DATE: October 8, 2020

RE: *Supplemental Narrative for Revised Plans* - Proposed Motor Truck Terminal at 142 East Haddam Road (Highway Commercial Zone)

Proposed Motor Truck Terminal  
Arborio Brothers, LLC  
142 East Haddam Road  
Salem, Connecticut  
Stormwater Quality Measures

**EROSION & SEDIMENTATION CONTROL PLAN**

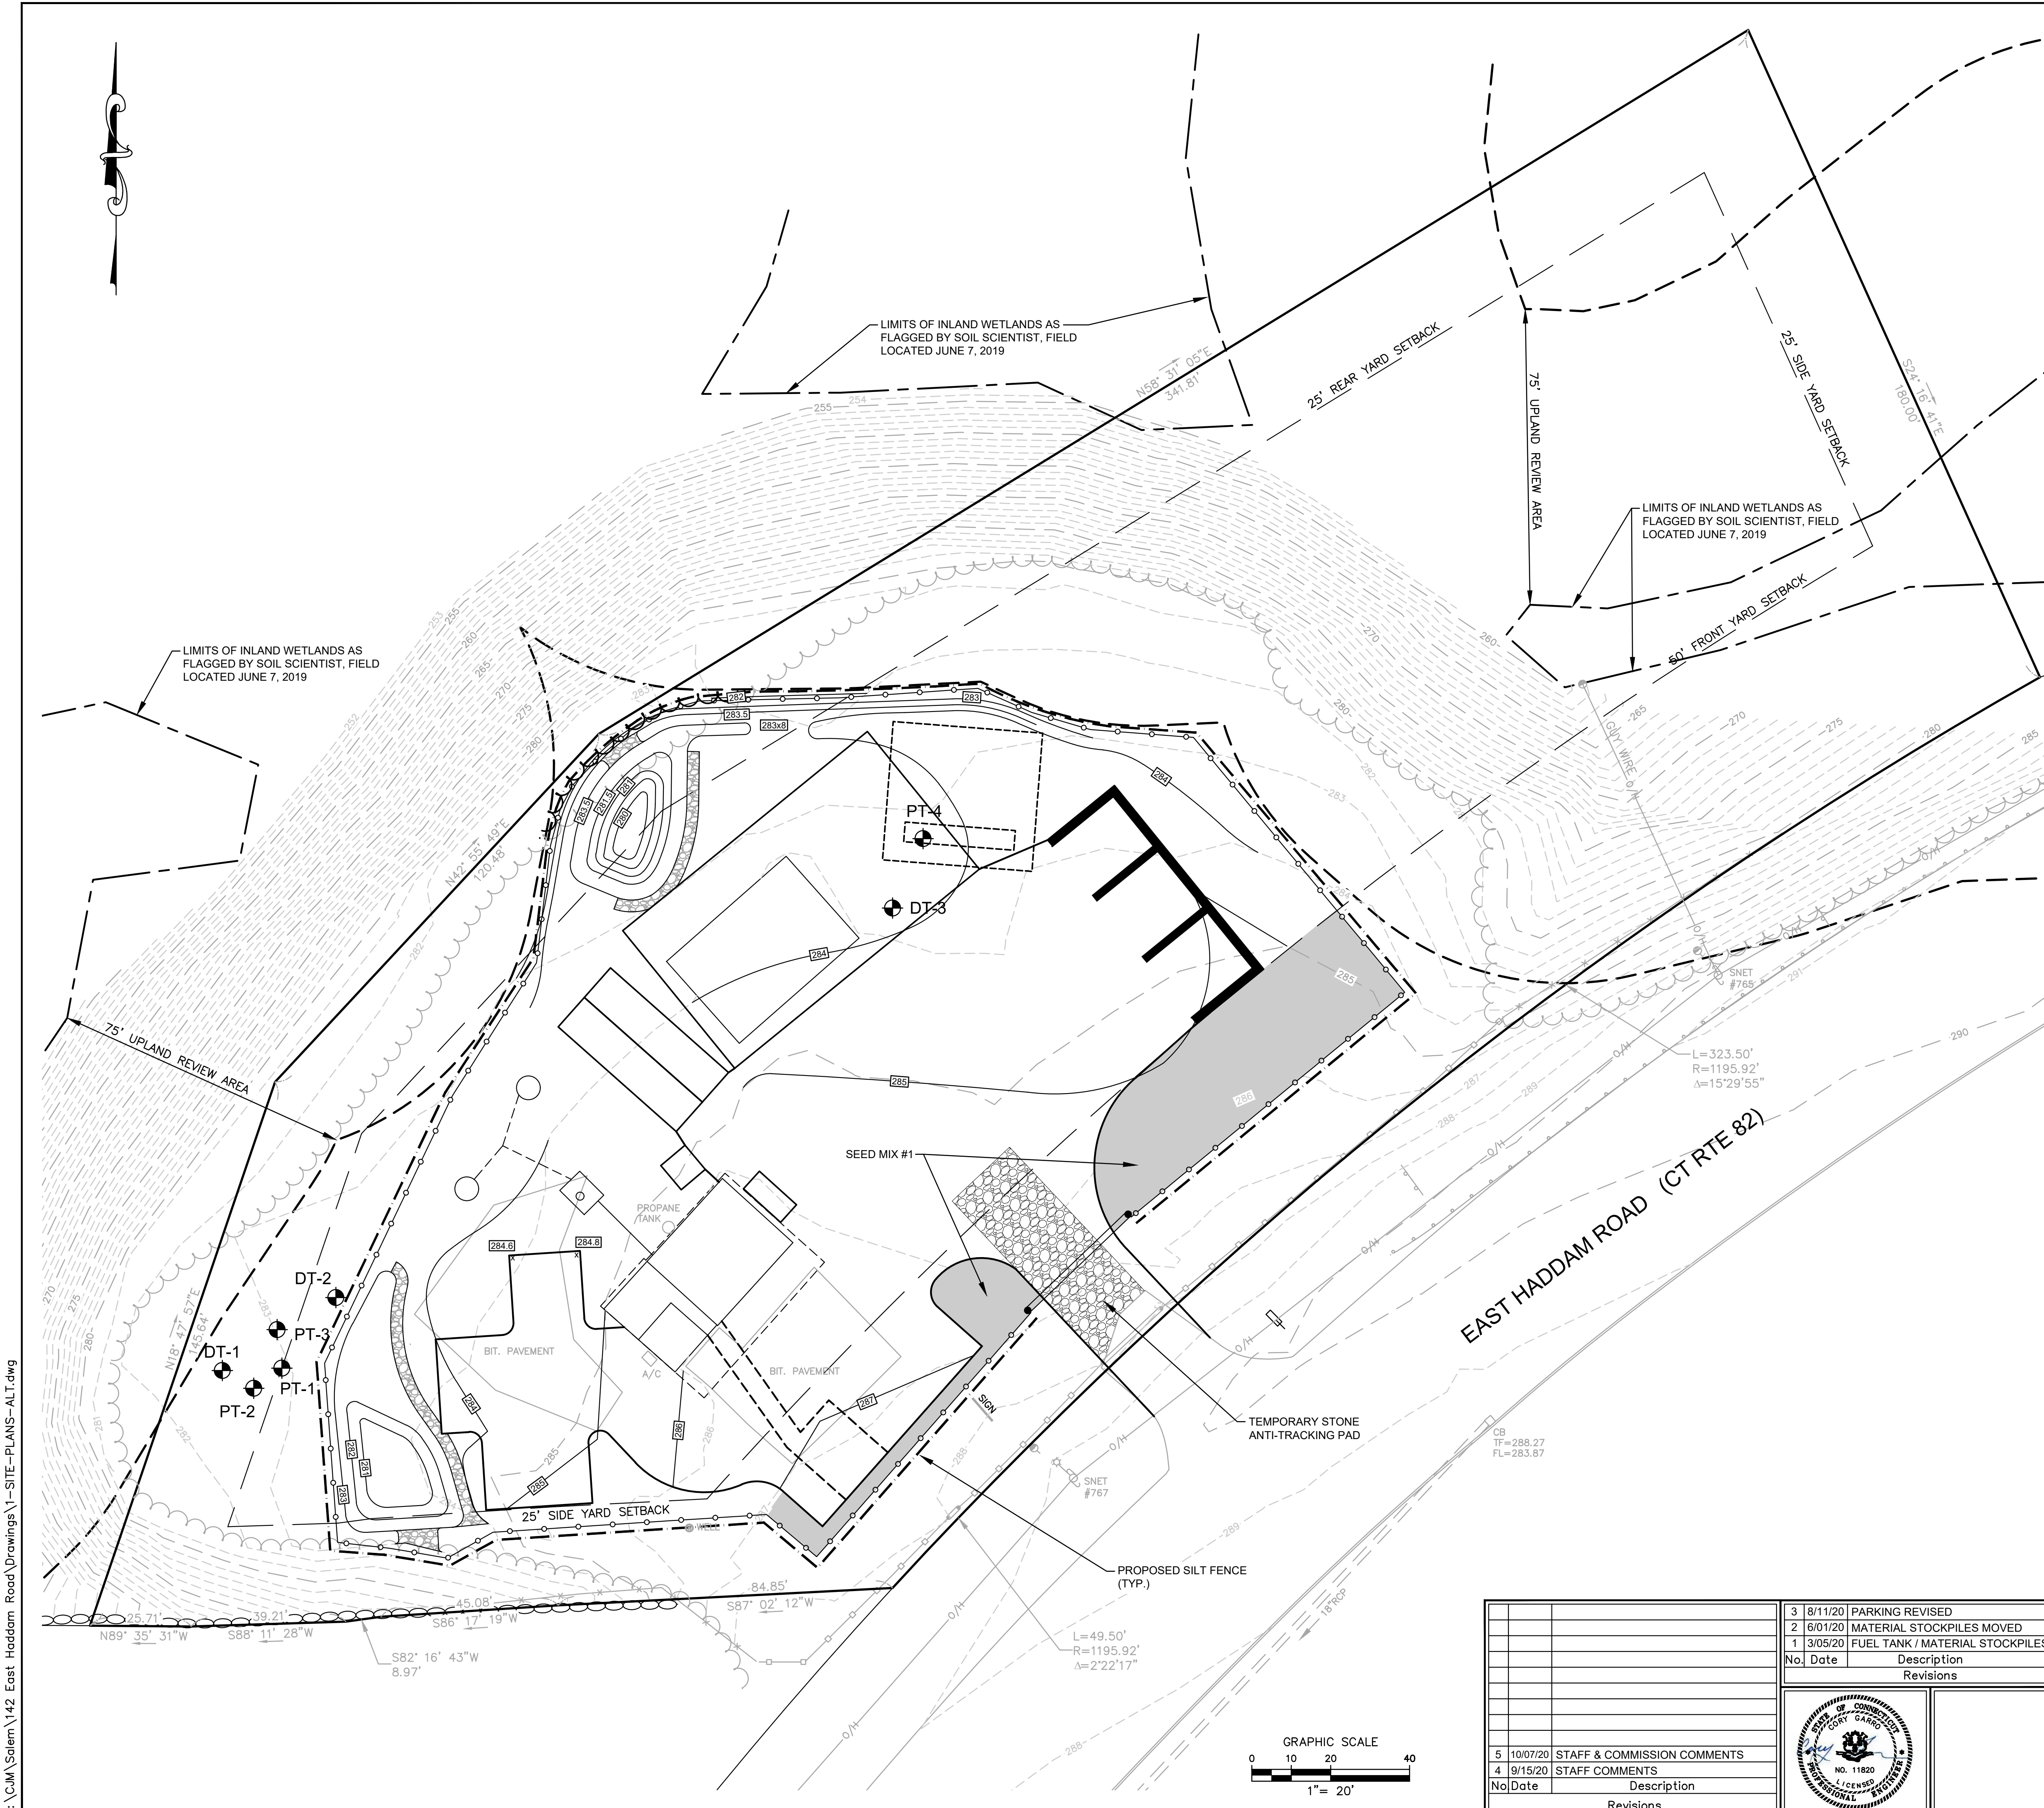
- Landscaping was increased along East Haddam Road and the proposed species were replaced with either native plants or cultivars of native plants. *Please see the Plant Schedule on Sheet 4 of 8 for additional information.* The new plan creates a complete row of landscaping along the front fence, while also allowing some visibility into the Site to meet the Applicants security concerns.

- Seed Mixture #1 (shaded in gray) was added to the plan to show the area to be regularly mowed within the Site's chain-link fence.
- The proposed equipment storage area and sand & stone material stockpile bins were moved further away from the limits of the upland review area.

- The bio-retention basins are redesigned, and maintenance schedules for the basins can be found at the top of *Sheet 4 of 8*.
  - **Basin #1** (adjacent to the employee parking area) was expanded.

- The new design exceeds the requirements of the 2004 CT Stormwater Quality Manual, the water quality storage volume required is 287 c.f. and the redesigned basin holds 921 c.f. *See attached Stormwater Quality Calculations revised 10/6/2020.*

- A 1-foot deep trench with round river rock was added to the east side of the basin.
    - Plants were added to the rim of the basin to provide additional on-site habitat.

- The depth of the proposed soil mix was increased to a minimum depth of 24", consisting of 50% sand, 20% compost and 30% topsoil.
    - An overflow weir was added.

- **Basin #2** (adjacent to the equipment storage area) was redesigned, pulled further away from the limits of the upland review area and additional grass area was added between the equipment storage area and the basin.

- The new design exceeds the requirements of the 2004 CT Stormwater Quality Manual, the water quality storage volume required is 1,494 c.f. and the redesigned basin holds 1,555 c.f. *See attached Stormwater Quality Calculations revised 10/6/2020.*

- A 1-foot deep trench with round river rock was added to the east side of the basin.
    - Plants were added to the rim of the basin to provide additional on-site habitat.

- The depth of the proposed soil mix was increased to a minimum depth of 24", consisting of 50% sand, 20% compost and 30% topsoil.
    - An overflow weir was added which directs any overflow water towards the off-site woody vegetation.

- Shipping container storage bins were relocated southeasterly of the equipment storage area.
- The location of the two light poles was adjusted slightly, based on the revised Site layout.
